STAFF REPORT TO THE PLANNING COMMISSION

SUBJECT: Minor Plat Alterations
AUTHOR: Greg Sant
DEPARTMENT: Planning and Building
DATE: January 7, 2025
TYPE OF ITEM: Administration Action

ITEM: ROCKY MOUNTAIN POWER BUILDING/GRADING PERMIT

AUTHOR: Greg Sant
DEPARTMENT: Planning and Building Department
DATE: January 7, 2025
TYPE OF ITEM: Administrative Action

LOT LINE ADJUST LOTS 3D & 14B
TO MAKE (3) BUILDABLE PARCELS

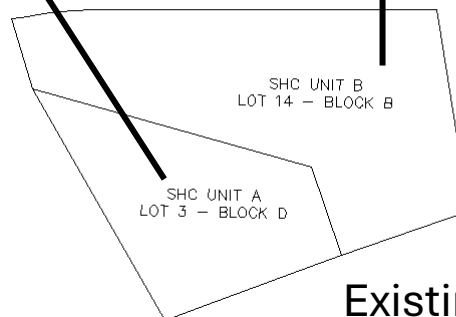
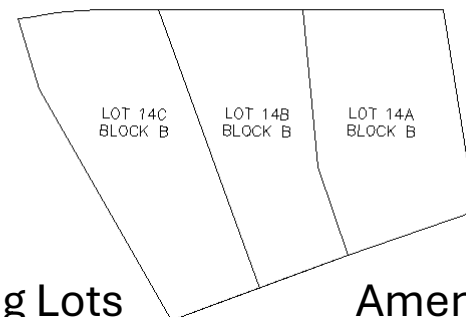
On November 27, 2024, the staff received an application from JOHN Stark and James Vincent to split 2 existing lots into 3 lots. The existing 2 lots are part of 2 different recorded plats: Ski Haven Chalet Unit A for Lot 3 – Block D and Ski Haven Chalet for Lot 14 – Block B. (See Exhibit A). By vacating these lots out of their plats, they can now be subdivided into 3 lots as shown on the Proposed Ski Haven Chalet Amended Units A and B.

1. The proposed amendment to the subdivisions conforms to the Town General Plan and Zoning regulations as outlined in the LMC. All lots will be .45 to .48 acres in size.
2. Fire Protection will not change and complies with all Town regulations.

3. The layout and design is responsive to the constraints of topography and geologic hazards.
4. This area is in an SAA that will start in the spring of next year. The new lot is not included in this SAA and the Applicant will need to negotiate with the SAA contractor to install the improvements at the Applicant's cost.
5. There is no incumbrance restricting the intended use of this lot.
6. All property taxes have been paid for 2024.
7. Applicants have worked with the County Recorder as to the best way to handle this alteration since it is spread over 2 plats. The proposed amended plat is attached for review. The Commission shall review signature block to insure that it is correct.

Staff recommends that this plat amendment be approved with the following motion: I move that the Minor Plat Alteration at 231 E. Snowman Dr. and 137 S. Snow Shoe Dr., also know as Ski Haven Chalet Units A and B; Lot 14 – Block B and Lot 3 – Block D be approved per the Findings and Analysis outlined above.

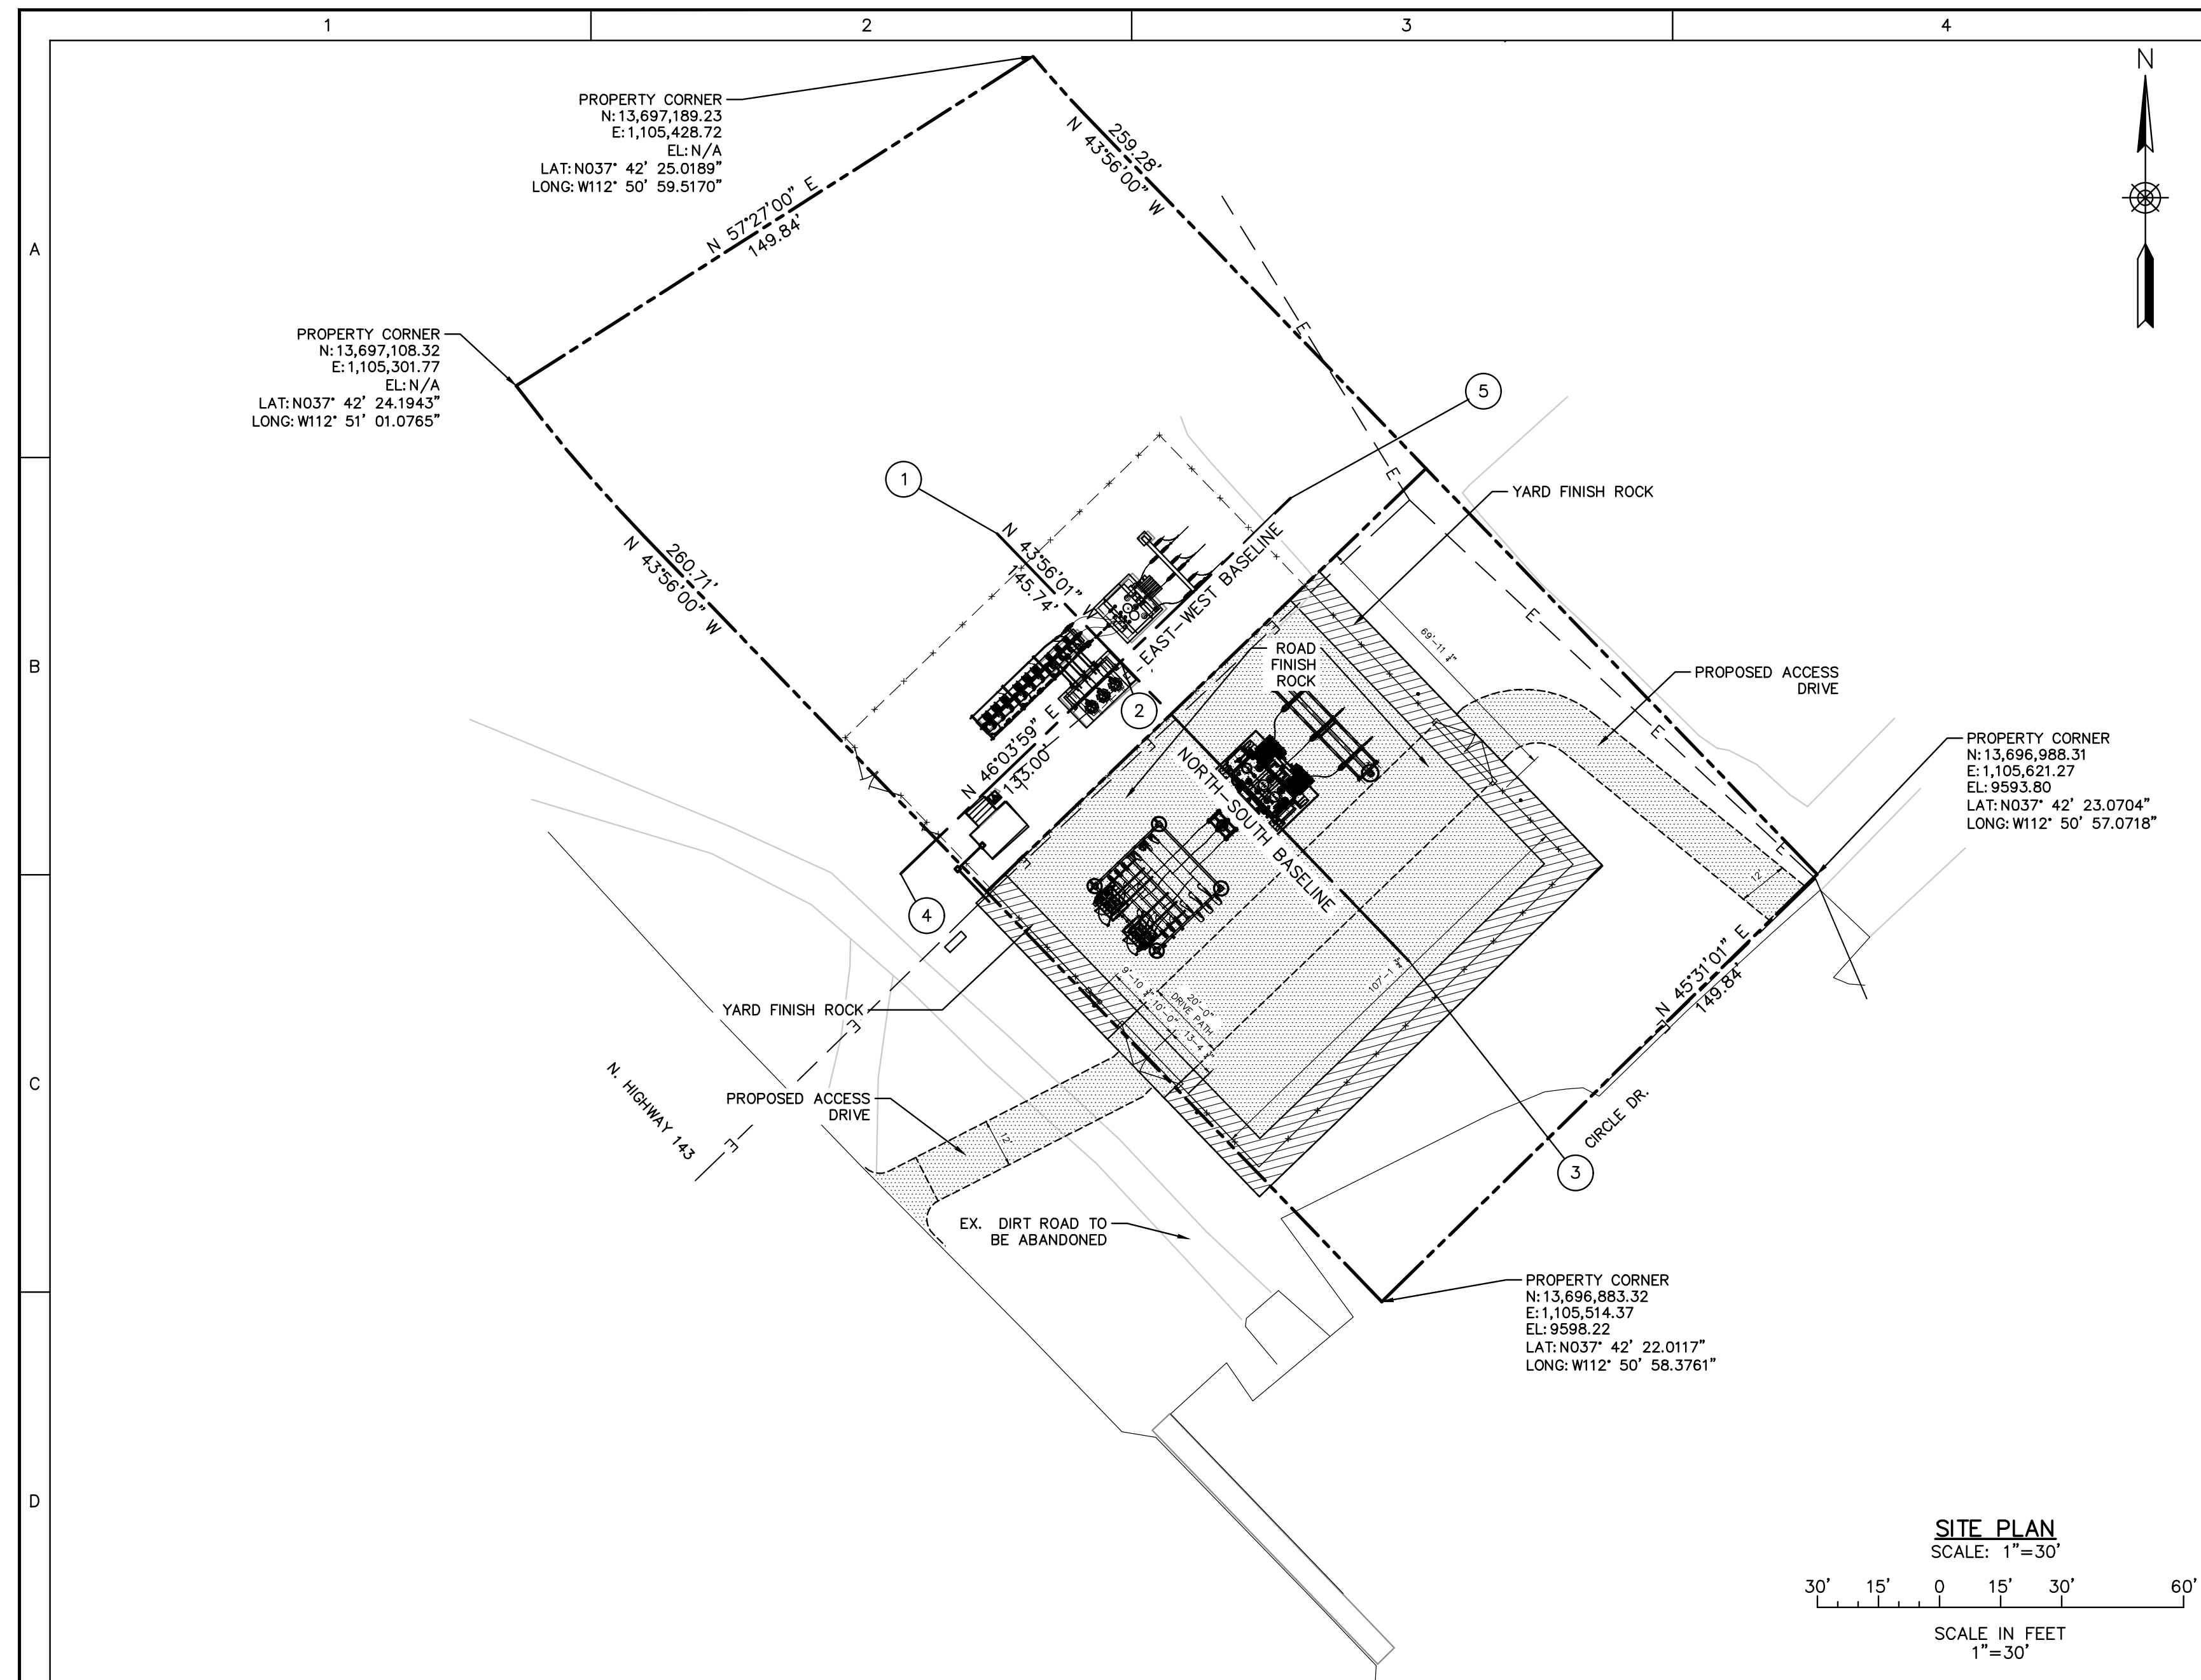
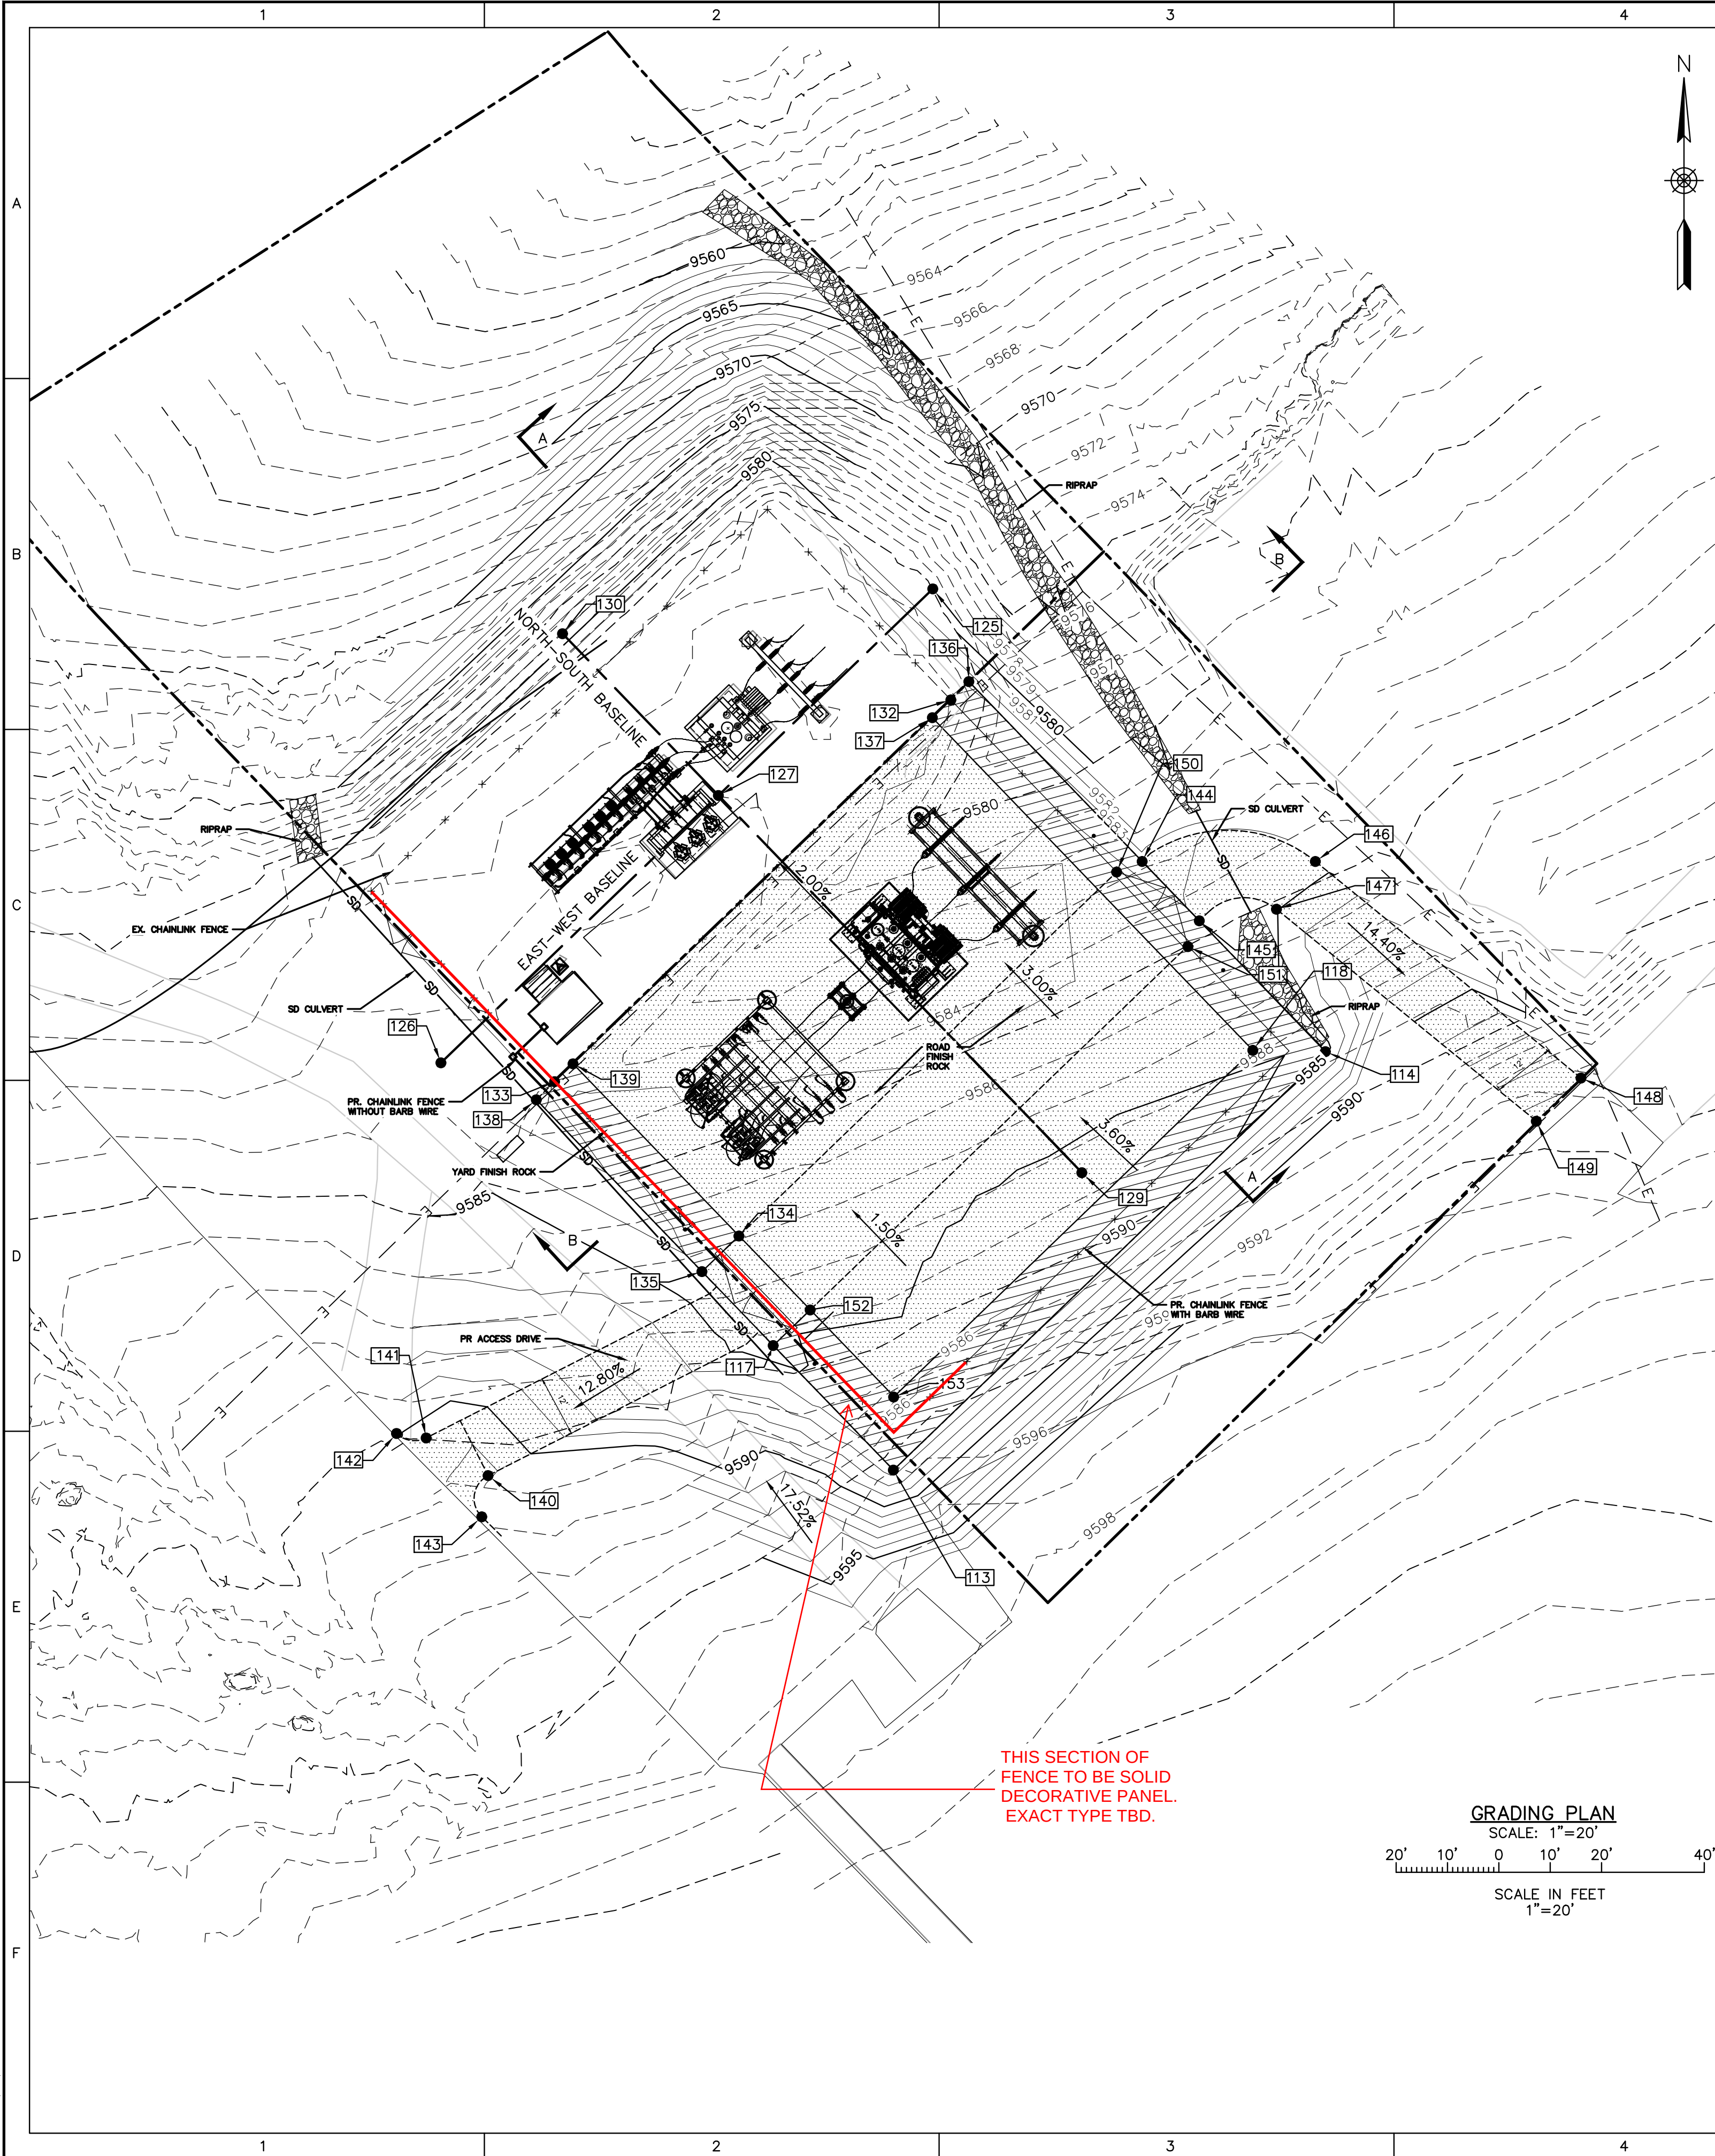
1. The grading, excavating, trenching, and clearing being proposed unfortunately is to clear the entire site of trees. This is required for safety reasons, i.e. trees falling onto the transformers, etc. and in keeping people out of the site. The grades and elevations of the site are already set by the existing substation. The site will be brought to a finished elevation of the existing substation. This will require both cut and fill.

4. Quantities to be removed from or brought to the site. – The site upon which this work will take place is 1.01 acres. There has been approximately 145 cubic yards of organic material removed from the site to date. There will be approximately 432 cubic yards of cut with approximately 163 cubic yards of imported fill. The site will be graded as to control all drainage and runoff.

5. Plan for storage and disposal of materials. – Most of the cut material will be hauled off. Some material will be used for the ramp at the east corner next to Apple Annies. This ramp will be used as access to the substation. Other materials that will be used from the cut material are rocks and boulders that will be used along the common property line with Apple Annies as a stone retaining wall.

7. Screening – Applicant has verbally agreed to use a decorative concrete wall that will meet Town standards to enclose this project.
8. There are 2 sites that are owned by RMP. This subject site is 1.01 acres, and the existing substation sits on .53 acres and has approximately 50% open space associated with it. Staff would suggest that the property line between the 2 parcels be vacated so that the overall site is 1.54 acres and the open space requirement will be met.

After reviewing the plans and meeting with representatives of RMP and Bulloch Dirt Works, it is the recommendation of staff to approve this Grading Plan based on the Findings of Facts and with the following conditions:

1. All work to follow the Grading Plan as submitted.
2. All measures to mitigate erosion, noise, dust smell and safety to be followed as outlined in the LMC.
3. The new site will be screened by a decorative concrete wall, the design of which will be agreed to by both RMP and Brian Head Town. Wall to be completed by the time the generators are installed in the spring of 2025. Furthermore, low vegetation will be installed around walls to breakup walls.
4. RMP will vacate the property line between the 2 parcels so that the larger 1.54 acre parcel meets the zoning requirements.
